HOPE CREEK GENERATING STATION
DOCKET NO. 50-354
NRC REVIEW OF STRUCTURAL/GEOTECHNICAL TOPICS

Attachment: Resolution of NRC Comments on
Structural/Geotechnical Topics

Response to NRC Audit

Chart for evaluation of liquefaction potential for sands for different magnitude earthquakes.

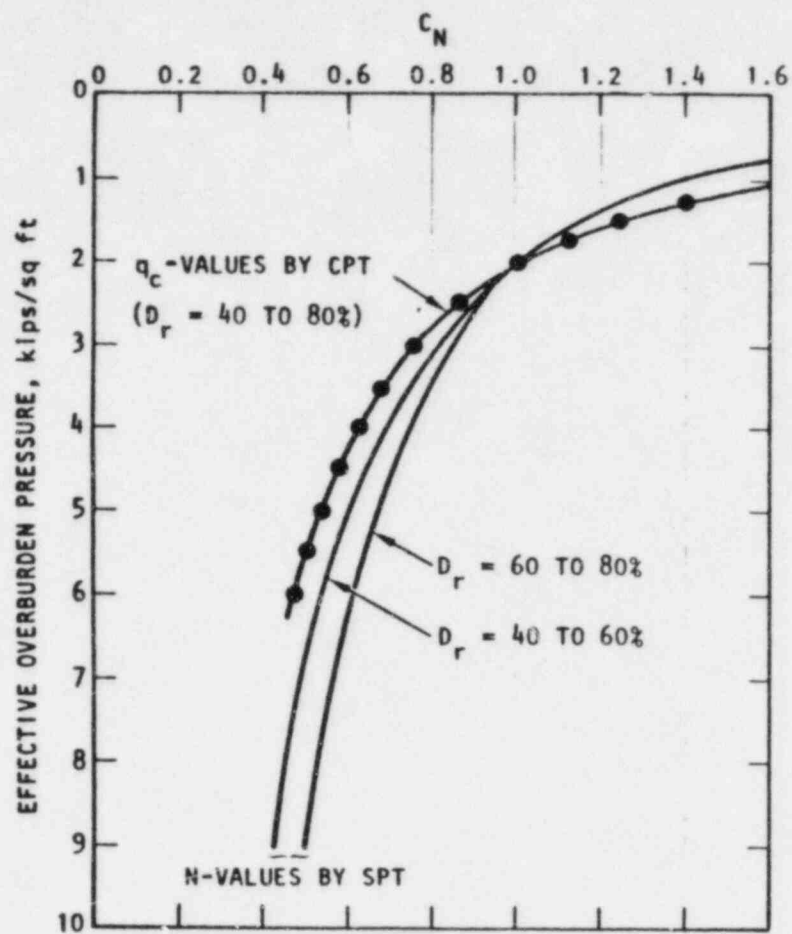
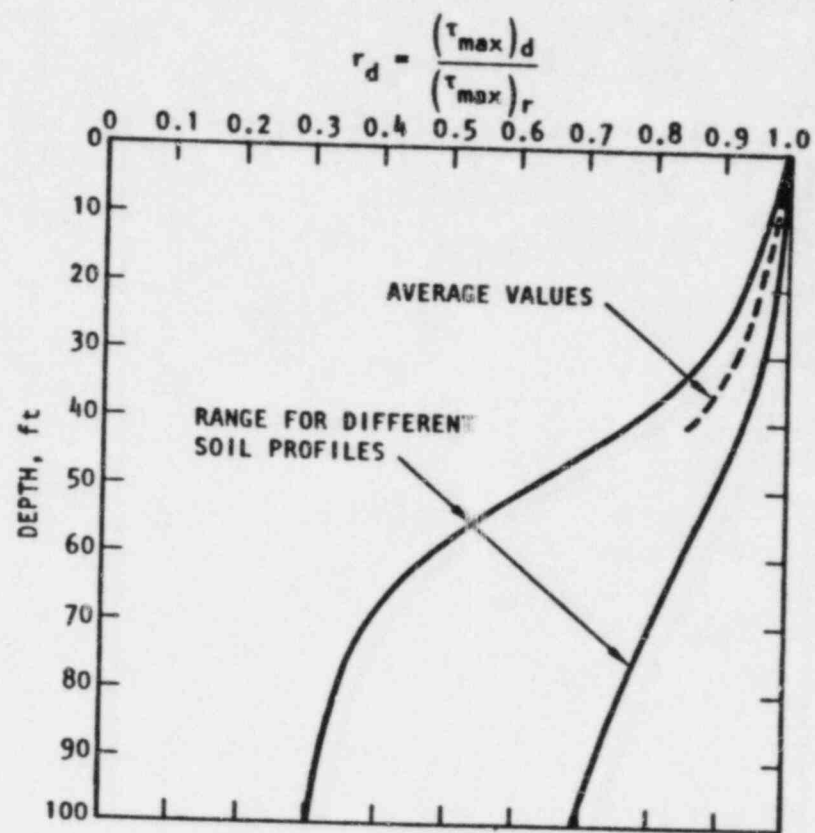
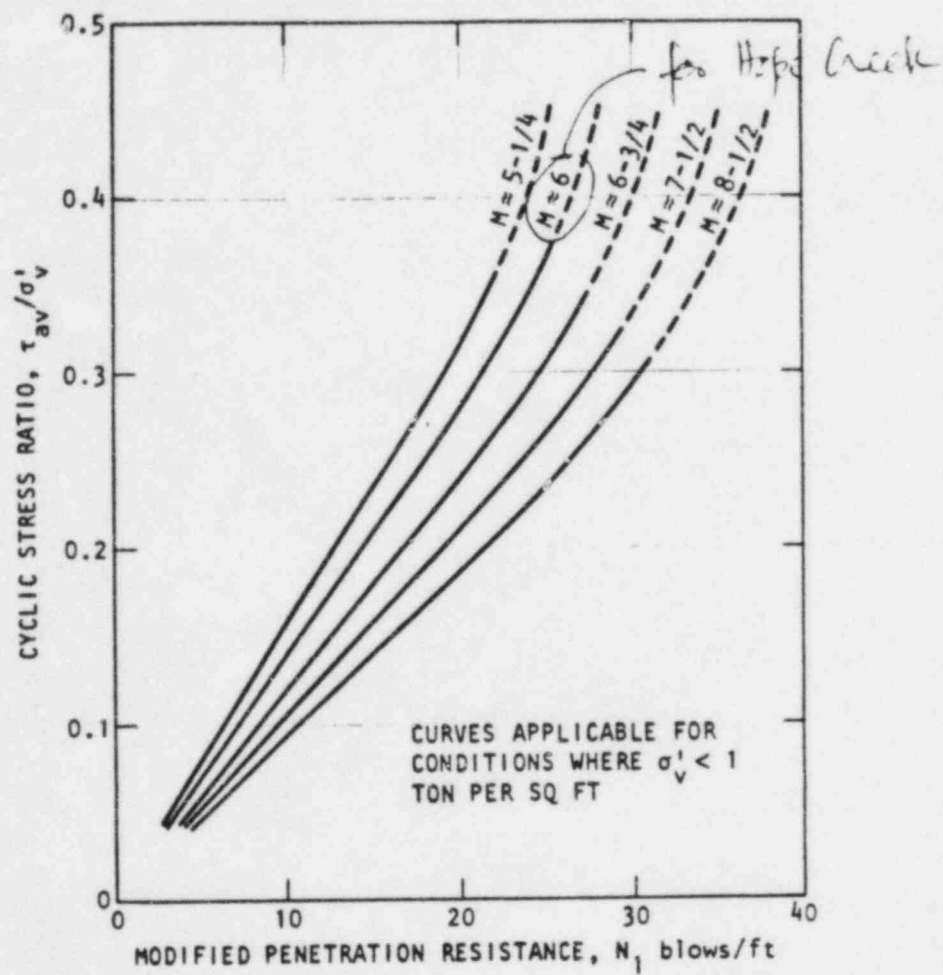
QUESTION: Provide liquefaction analysis of river bottom sands using simplified Seed approach to determine induced shear stresses and compare dynamic shear strengths from laboratory tests.

In response to this action item, a simplified assessment based on the Seed and Idriss procedure has been performed. For this assessment, the cyclic strength of the saturated sandy soils was estimated from both dynamic laboratory tests and the average field SPT blowcount data. The calculations indicate that even with the various conservative assumptions made in the simplified analyses, the average factor of safety against liquefaction of the river bottom sands is well above unity. Calculations for the simplified analyses are attached.

The margin of safety will be higher than 1.24 in general since:

- 1) Failure criterion of $\pm 2.5\%$ axial strain is very conservative for overall stability
- 2) Test data used is for the relatively less dense sands - samples corresponding to SPT 24 to 35.

FIGURE B-216

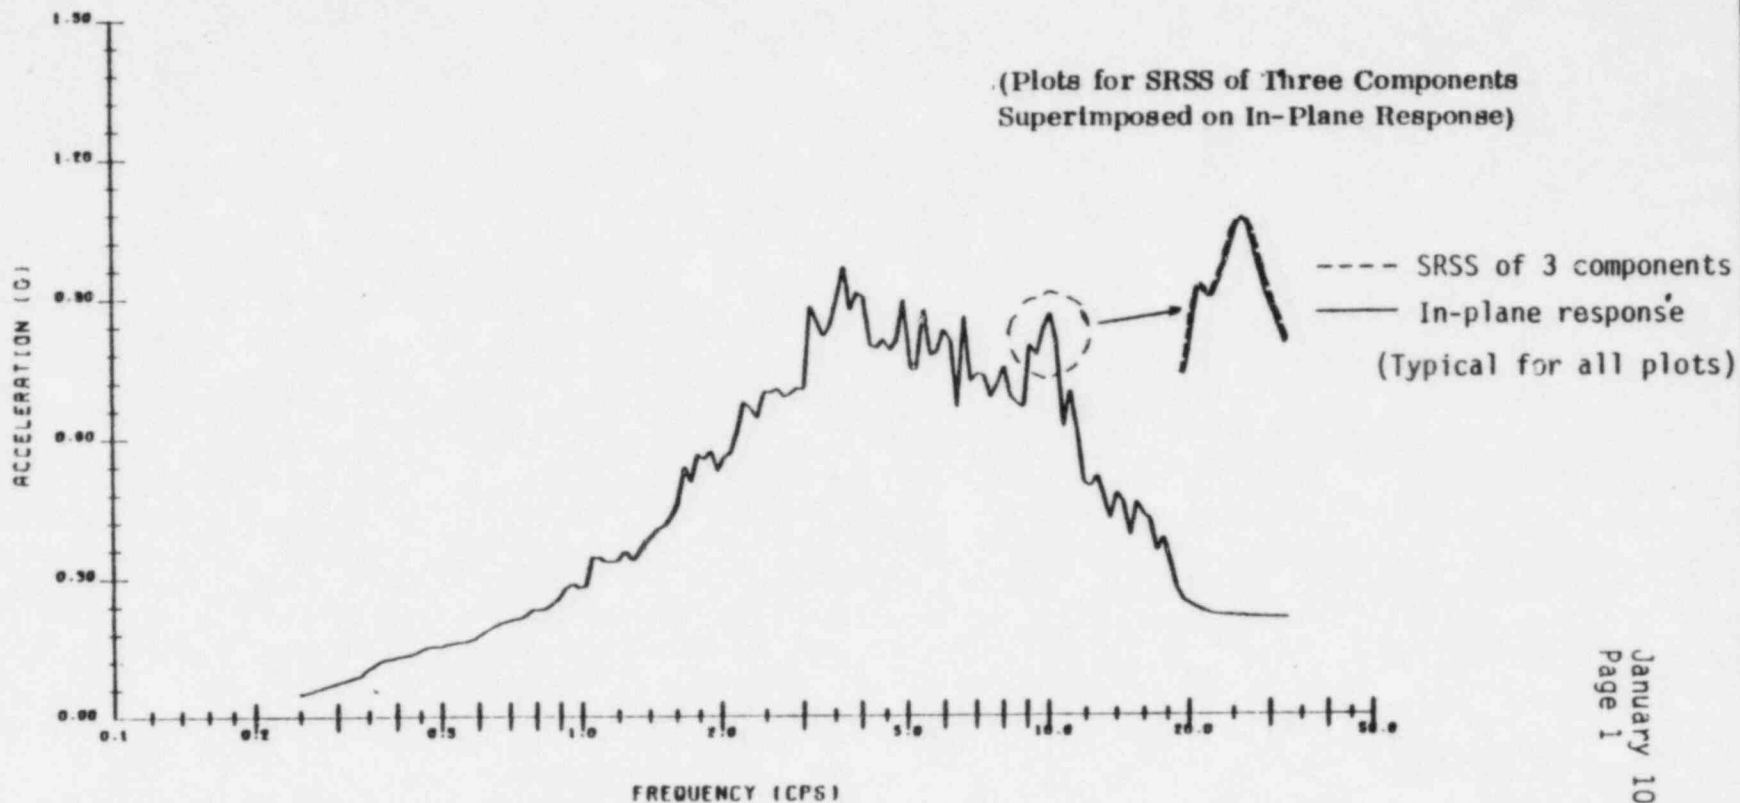
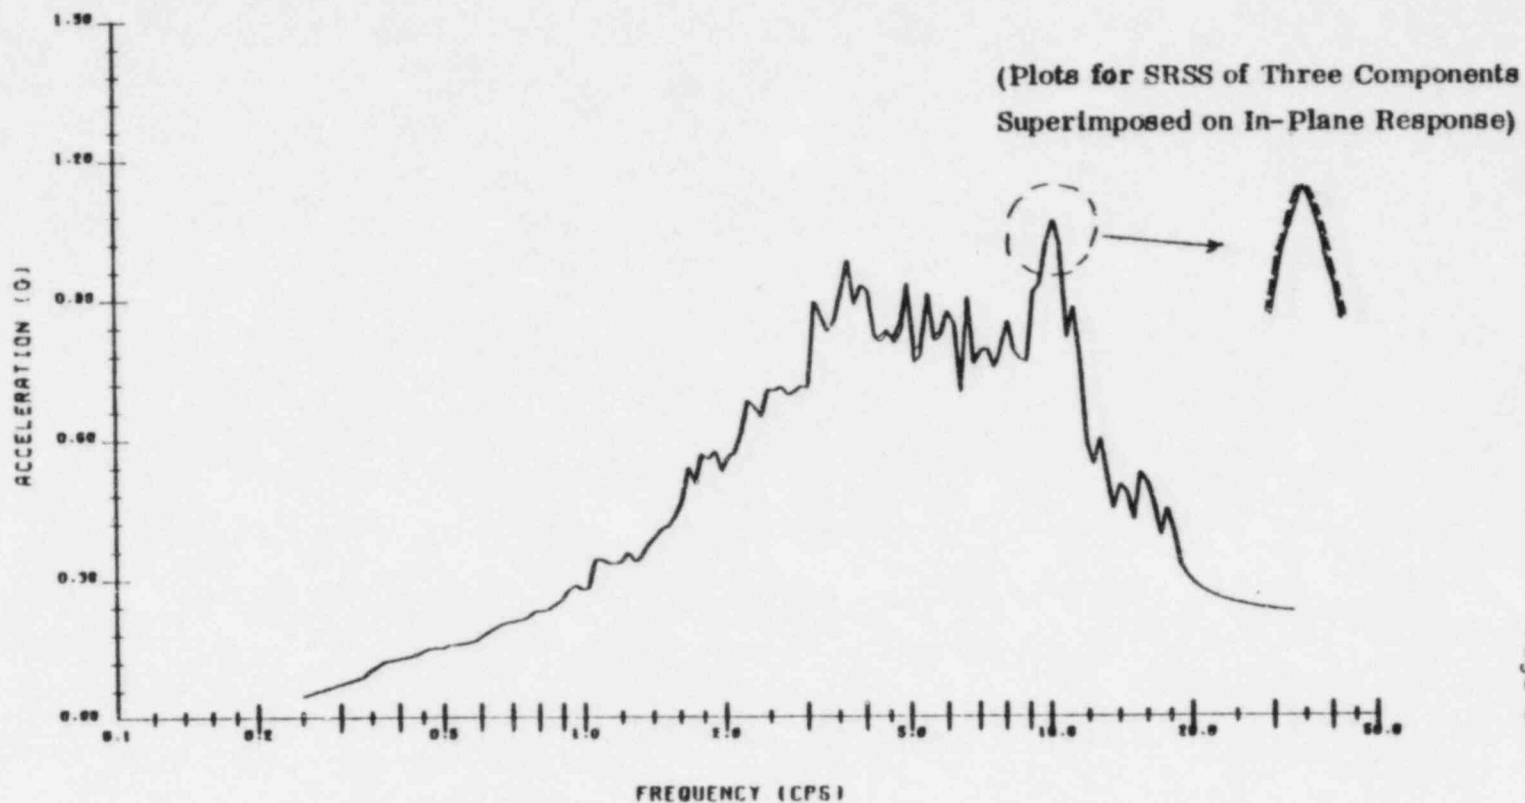
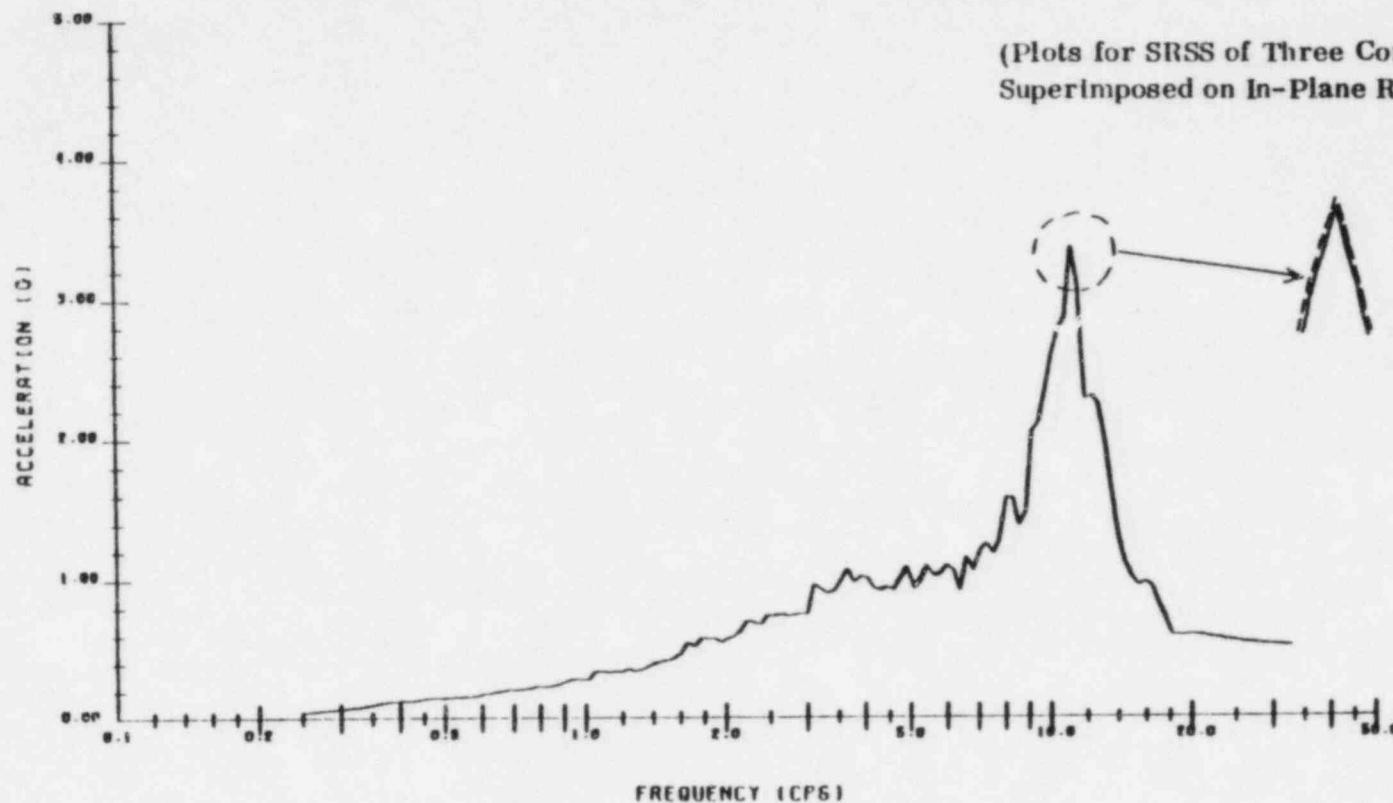
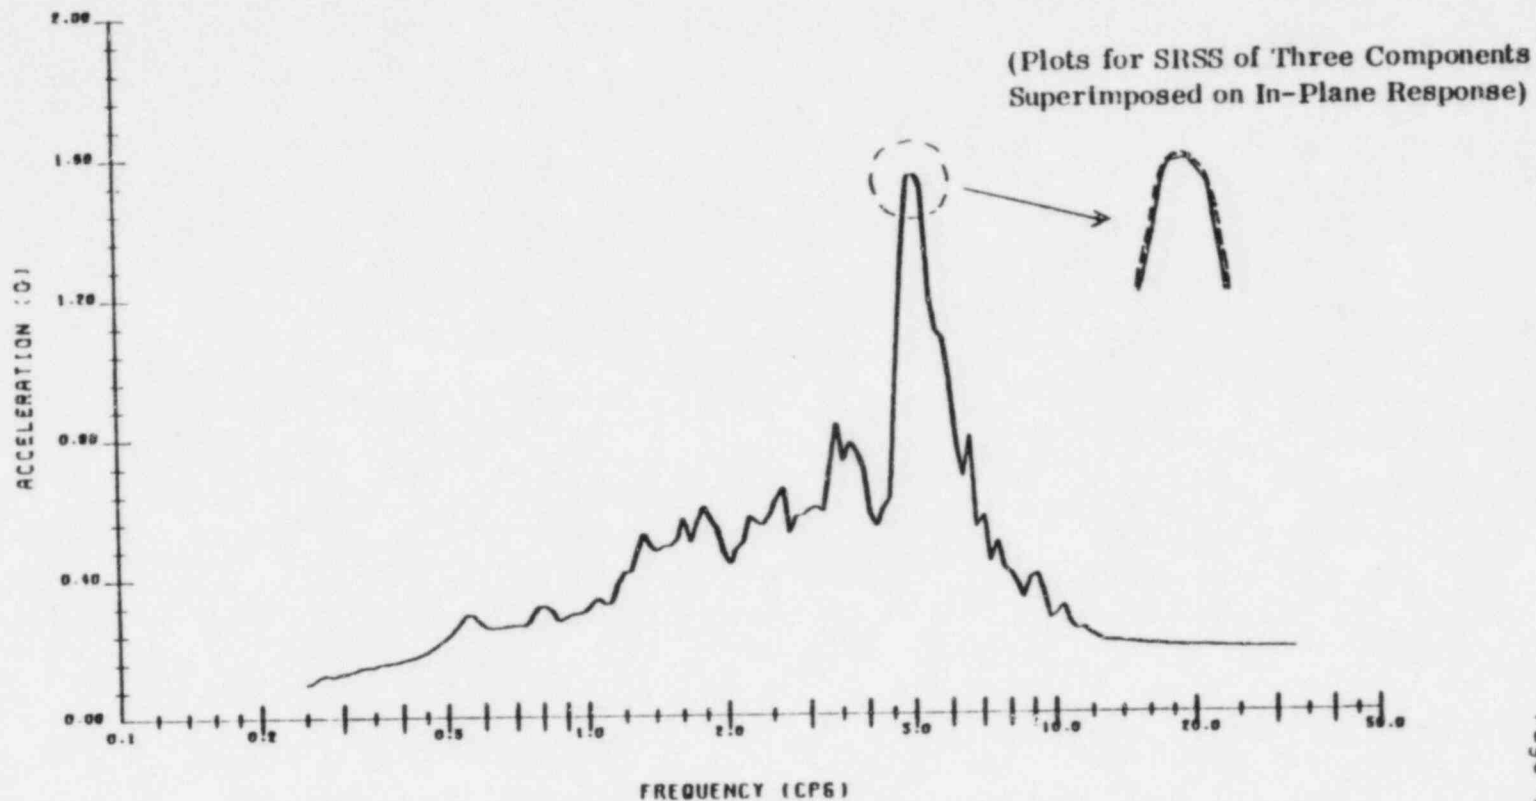
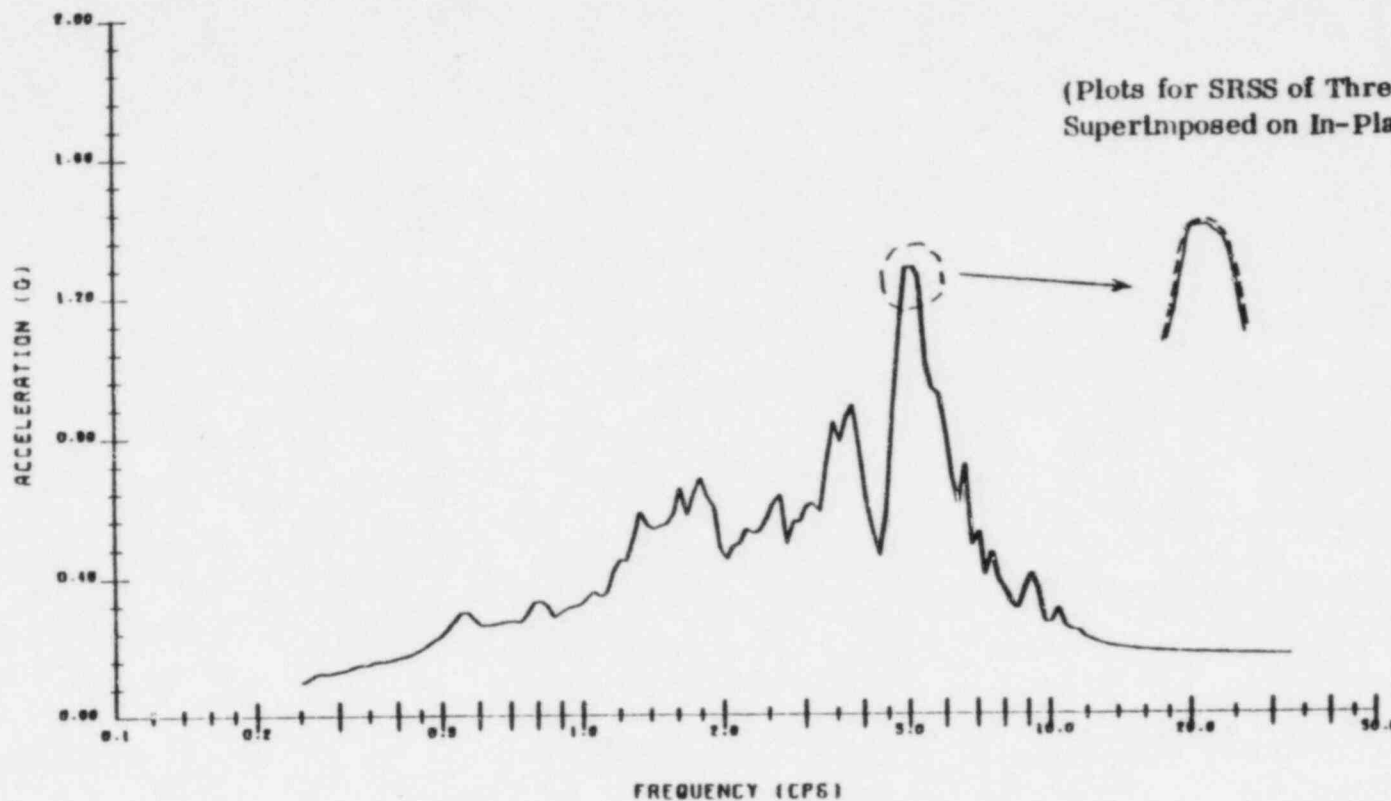
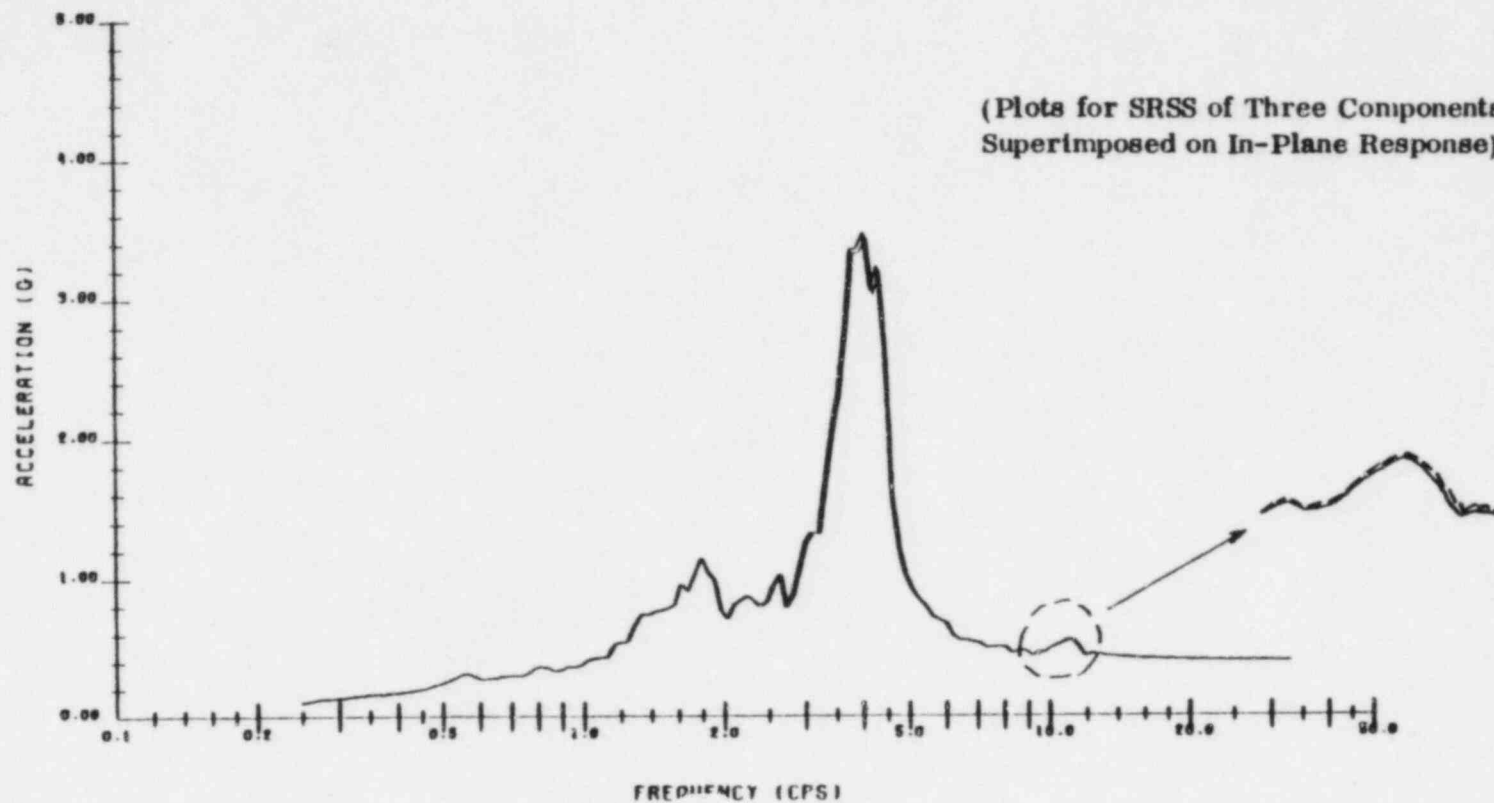
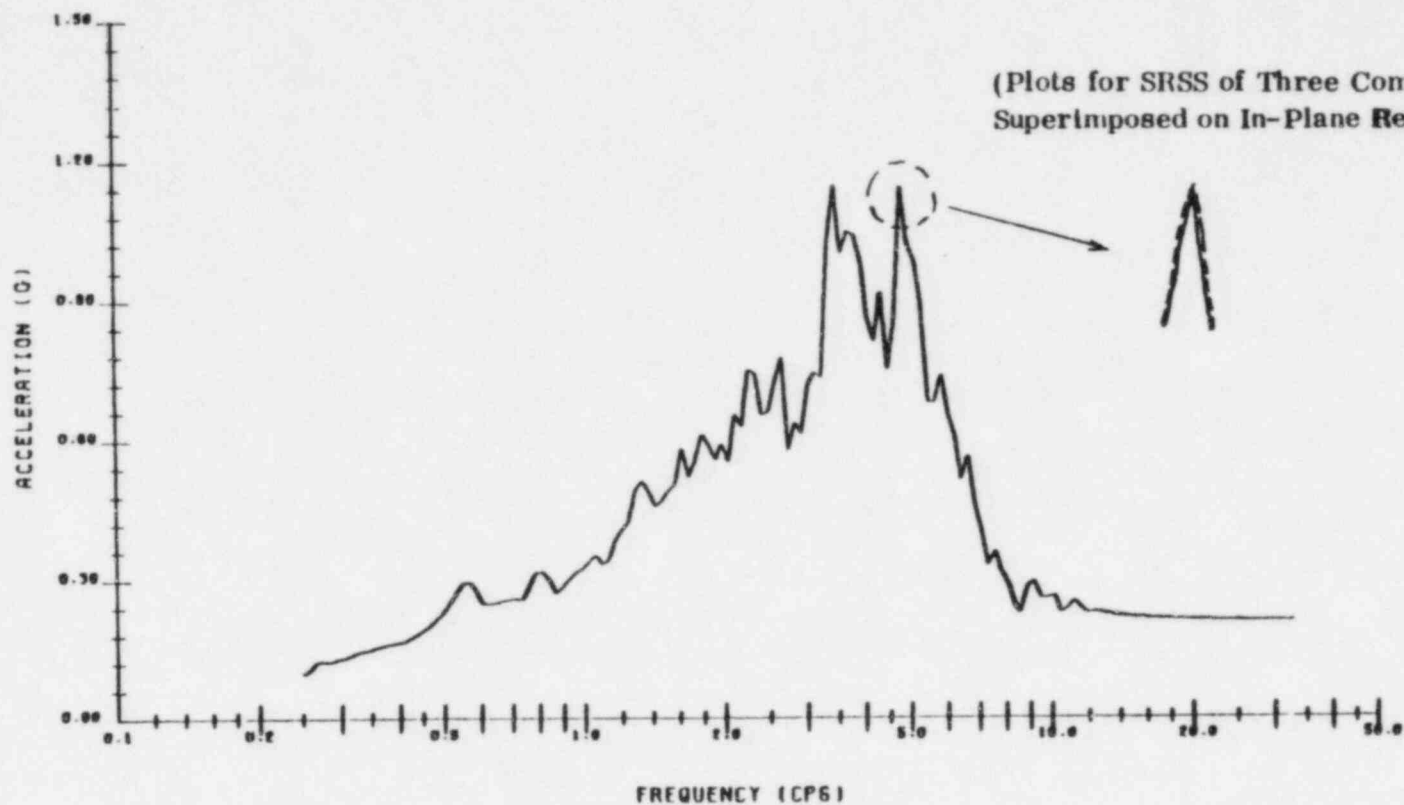
Question: Provide example calculation for combination of NS, EW, and vertical responses.

Response: As defined by the Regulatory Guide, the spectral accelerations for three earthquake components were summed at each frequency point using an SRSS-type procedure. As demonstrated by Figures B-216 through B-224, the out-of-plane components do not contribute significantly to the in-plane spectra, and were clearly not required for the development of the floor response spectra.
